Change Notice

MB Series

Changes to Material of the Operating Plate for Specific Models of MB Series

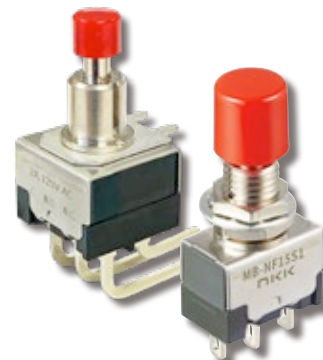
There will be a revision to the material of the operating plate on the snap-action MB Series Pushbuttons, for both MBNR and MBNF (formerly MB2400 and MB2500). MBNR will include bushing mount, bracket PC mount, and snap-in mount, and MBNF will affect bushing mount models.

The operating plate material, currently polyacetal, will change to polybutylene terephthalate (PBT). This revision will apply to both standard and custom switches. Effected standard part numbers are listed on the table below and on page 2.

Part	Before Change	After Change
Operating Plate	Polyacetal	Polybutylene Terephthalate (PBT)
